**PLANNED UNIT DEVELOPMENT  
& SUBDIVISION STAFF REPORT****Date: December 18, 2008****DEVELOPMENT NAME**

Papa John's Subdivision

**LOCATION**5401 Cottage Hill Road  
(Southwest corner of Cottage Hill Road and Vivian Drive)**CITY COUNCIL  
DISTRICT**

Planned Unit Development Approval to allow shared access between two building sites, and Subdivision Approval to reconfigure two existing legal lots of record.

# SITE PLAN

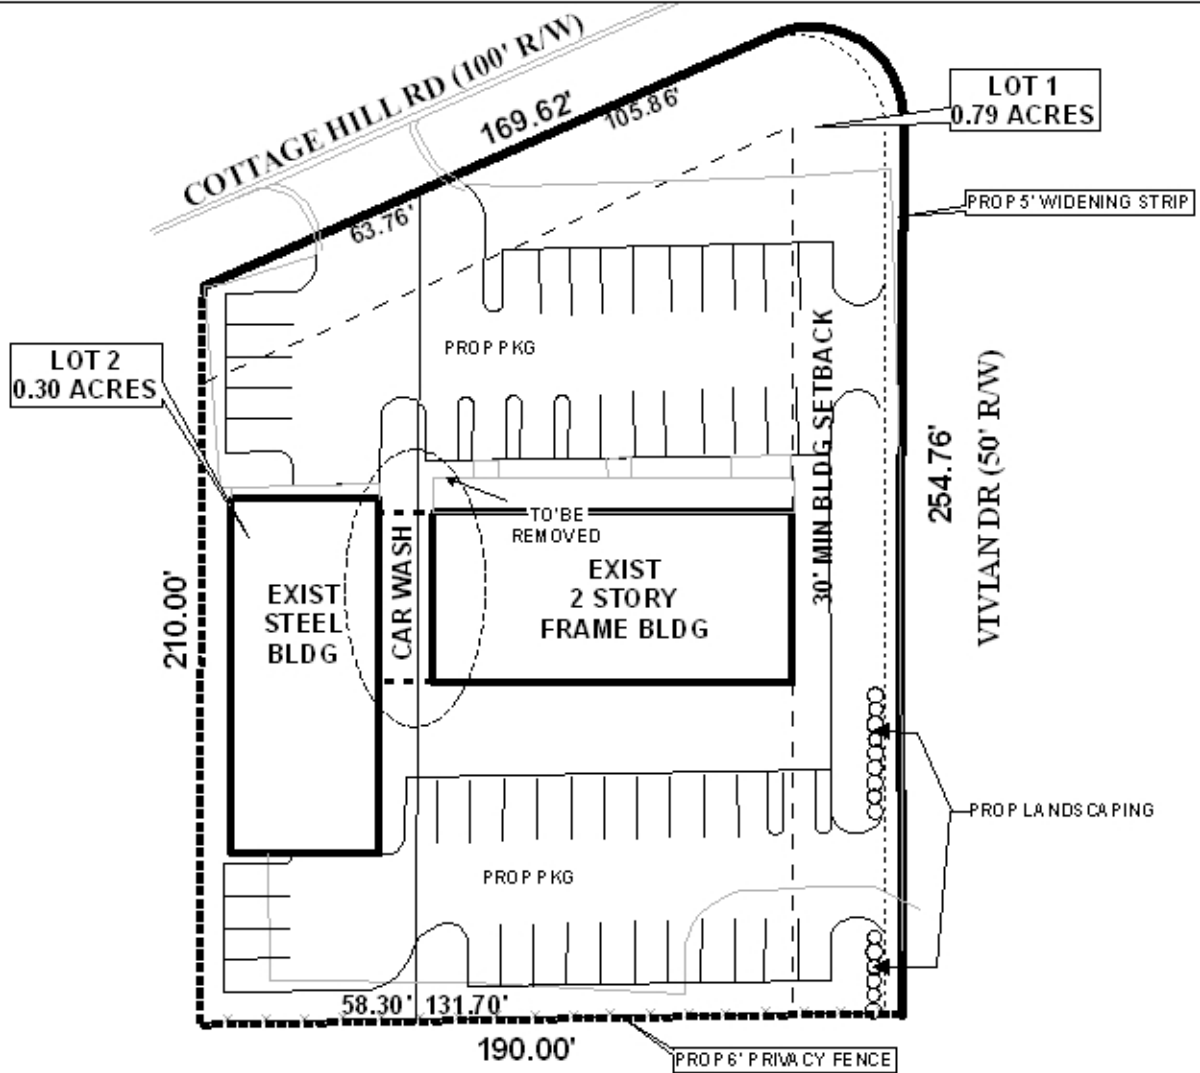
Lot 1 has approximately 255' of frontage, currently with an open continuous curb cut, along Vivian Drive. As illustrated on the site plan, the applicant is replacing this continuous curb cut with landscaping and providing two standard curb cuts to Vivian Drive. The exact sizes, locations, and designs of the proposed curb cuts will have to be approved by Traffic Engineering and conform to AASHTO standards. Furthermore, as Cottage Hill Road is a major street, the subdivision shall be limited to one curb cut to Cottage Hill Road, which is to be shared by the two lots.

As illustrated (with acreage) on the plat / site plan, the lots meet the minimum size requirement for developments with access to public water and sewer; however, it recommended that the applicant revise the plat / site plan to label the lots with their sizes in square feet (in addition to acreage), or provide a table on the plat with the same information.

The site plan illustrates the shared parking and access from both Cottage Hill Road and Vivian Drive. The applicant has demolished a portion of the existing structure, thereby creating two separate buildings (4,211 and 4,939 square feet). According to the applicant, the uses of these buildings will be a combination of office space and automotive maintenance, all requiring one parking space for every 300' of gross floor area (31 are required for entire site; 53 are provided). Thus, site plan is in compliance with Section 64-6 of the Zoning Ordinance; however, it is recommended that the applicant revise the site plan to include information regarding the uses of the site.

The site abuts residentially zoned property to the South and directly across Vivian Street to the East. As required by Section 64-4 of the Zoning Ordinance, the applicant is providing a 10' buffer strip with a 6' privacy fence along the southern boundary; however, it should be no taller than 3' within the 25' setback line from Vivian Drive, and the applicant should revise the site plan accordingly. Also provided is a three foot hedge along Vivian Drive where across from residentially zoned property. Furthermore, as required by Section 64-6.A.3.c of the Zoning Ordinance, any lighting for the parking lot shall be so arranged that the source of light does not shine directly into adjacent residential properties or into traffic.

There is no indication on the site plan as to the proposed location of any dumpster or other waste storage facility. The location of the storage area for the dumpster must be illustrated on the site plan and labeled, and the location and required screening must comply with Section 64-4.D.9. of the Zoning Ordinance, as well as with all other applicable regulations.

- 1) completion of the subdivision process;
- 2) placement of a note on the site plan stating that Planned Unit Development review is site plan specific; therefore any future changes (parking, structure expansion, etc.,) must be resubmitted for Planned Unit Development review, and be approved through the planning process;

- 3) labeling of the five foot widening strip, along Vivian Drive, as being dedicated to the City of Mobile;
- 4) placement of a note on the site plan stating that Lot 1 is limited to two curb-cuts onto Vivian Drive, with the sizes, designs and locations to be approved by Traffic Engineering and in conformance with AASHTO Standards;

- 5) placement of a note on the site plan stating that the subdivision is limited to the one existing curb cut to Cottage Hill Road, which is to be shared by the two lots;

- 6) revision of the site plan to include information regarding the uses of the site;
- 7) revision of the privacy fence, along the Southern property line, to no taller than three feet within the 25' minimum building setback from Vivian Drive;

- 8) placement of a note on the site plan stating that any lighting for the parking lot shall be so arranged that the source of light does not shine directly into adjacent residential properties or into traffic, as required by Section 64-6.A.3.c of the Zoning Ordinance;

- 9) provision of a dumpster, screened from view and in compliance with Section 64-4.D.9 of the Zoning Ordinance, or placement of a note on the site plan stating that no dumpster will be provided;

- 10) placement of a note on the site plan stating that the site must be developed in compliance with all local, state and Federal regulations regarding endangered, threatened or otherwise protected species;

- 11) submission of a revised Planned Unit Development site plan to the Planning Section of Urban Development prior to signing the final plat;
- 12) full compliance with all other municipal codes and ordinances; and
